## EUC Resource Planning Working Group Questions

Batch 3

October 12, 2023

Actual Emissions superimposed over the original Resource Plan projection

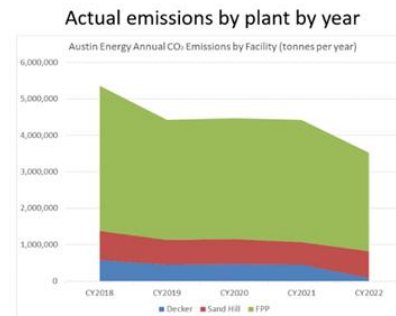
2. Can you please provide full page high def versions of these graphs that are more readable?

Please see accompanying PowerPoint slides. These graphics were all prepared based off of screen shots. Unfortunately, there are no hi-res. versions available.
